January 23, 2017

Subject: Preliminary Geotechnical Consultation Letter
North Abutment Scouring Geotechnical Issues
Hakalau Stream Bridge (No. 29-3)
Hilo, County of Hawaii, Hawaii

Insert 2. Looking south from north abutment.

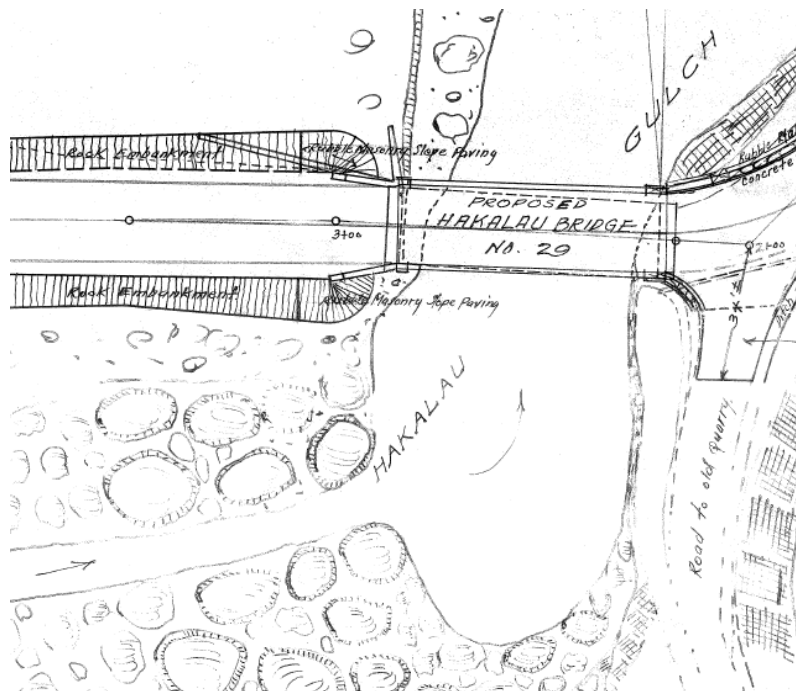
- a. The Old Mamalahoa Highway and Bridge 29-3 provide access to a beach park and maintenance of the steel truss supported Mamalahoa Highway (19) bridge crossing Hakalau Gulch.
- b. Only one lane traffic was allowed to cross the bridge, and weight limit was limited to 6 tons (Insert 2).
